RE: Request of Mariners' Church of Detroit for PC (Public Center) Special District Review of proposed exterior alterations to 170 East Jefferson Avenue – Mariners' Church of Detroit
(RECOMMEND APPROVAL WITH CONDITIONS)

MASTER PLAN

for
MARINERS' CHURCH OF DETROIT
170 E JEFFERSON AVE, DETROIT, MI 48226

Site Lighting

October 2022 Staff Photo of Removed Sign Location

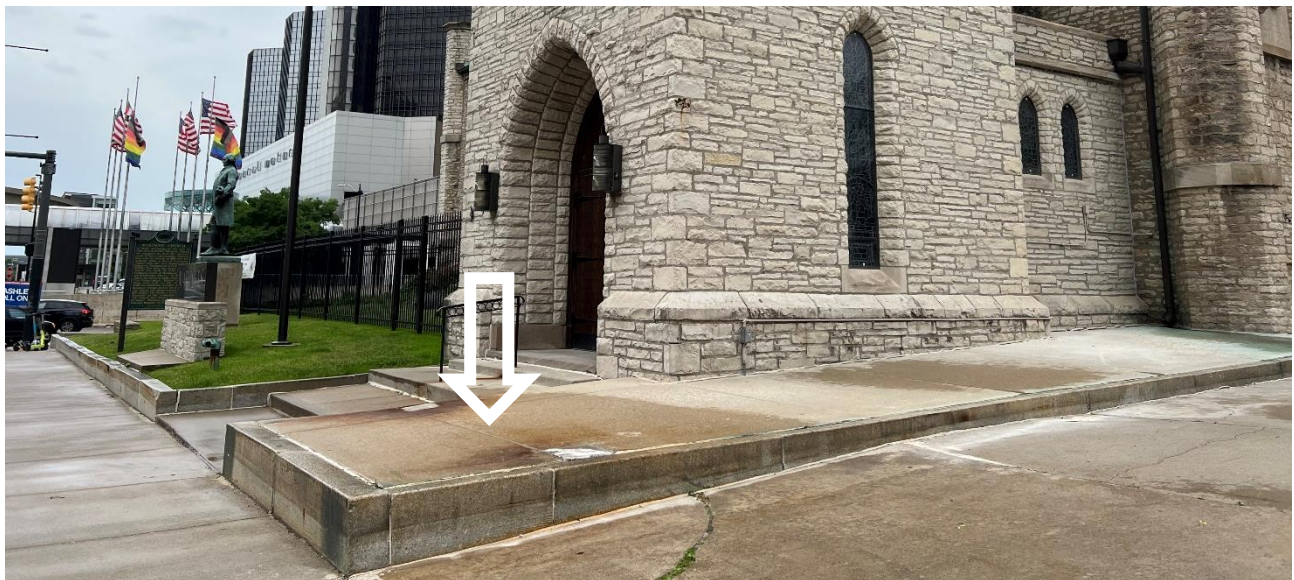
3. Signage. Sometime during early-to-mid 2022, the existing readerboard type pole sign facing East Jefferson Avenue was removed from the site, see the below images for verification. It is our understanding that the church plans to replace this sign in the near future, potentially with

an upgraded digital sign similar to the removed sign. At this time, the applicant is not seeking approval of a replacement sign in order to proceed with more urgent building improvements, and the Master Plan indicates that the construction of any replacement sign in this location would be performed under a separate sign review and permit. Therefore, staff recommends that City Council delegate PC District review authority for any replacement sign to the City Planning Commission so that it can be reviewed administratively, along with the permitting authority BSEED. If City Council does not wish to delegate this authority to CPC, the applicant may pursue this replacement sign later as part of another PC District review.

Staff recommends that City Council delegate PC District review authority for any replacement sign to the City Planning Commission so that it can be reviewed administratively, along with the permitting authority BSEED. If City Council does not wish to delegate this authority to CPC, the applicant may pursue this replacement sign at a later date as part of another PC District review.

22010.00
job numberA108
sheet number

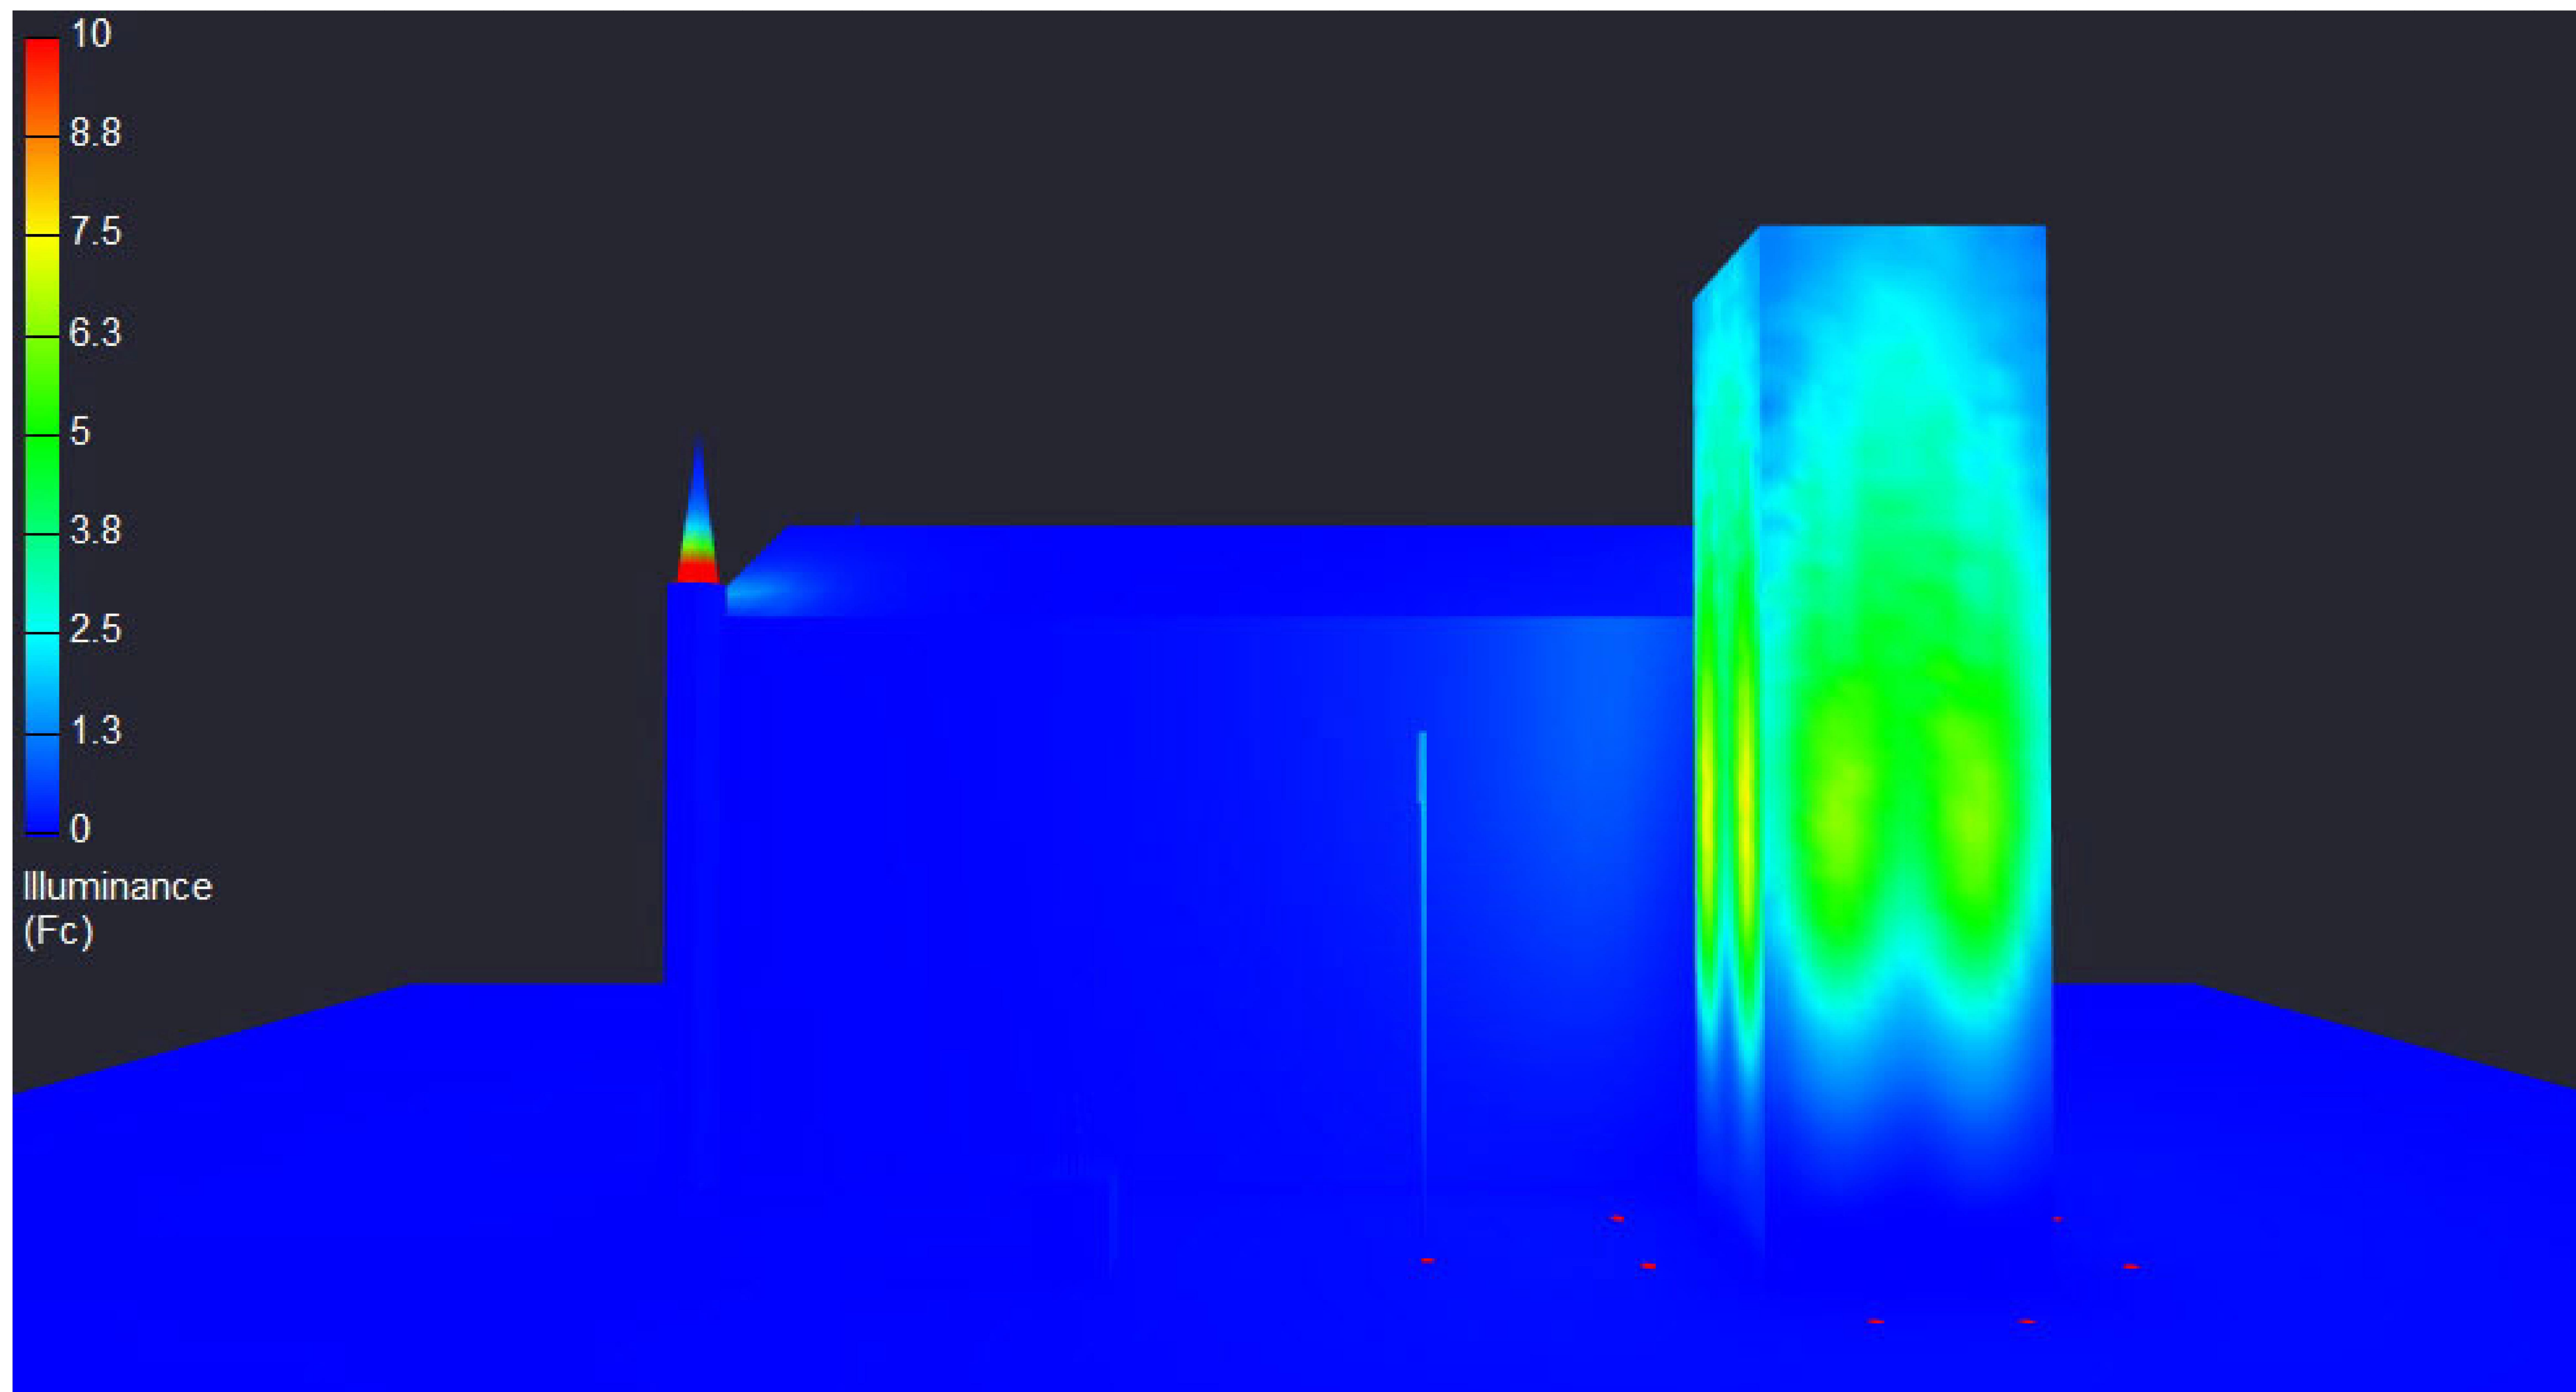
- b. CPC staff finds that the revised Site Lighting plan dated July 28, 2022, would take reasonable measures to limit light spillover and nightglow as illuminance levels depicted on sheets A106, A108, and A110 indicate that the highest levels of illuminance would be focused on building facades, the tower, and pinnacles, and would not be focused off-site or directly into the sky. Additionally, there are numerous examples of buildings, especially churches, located within the Central Business District that have similar focused up-lighting provided.
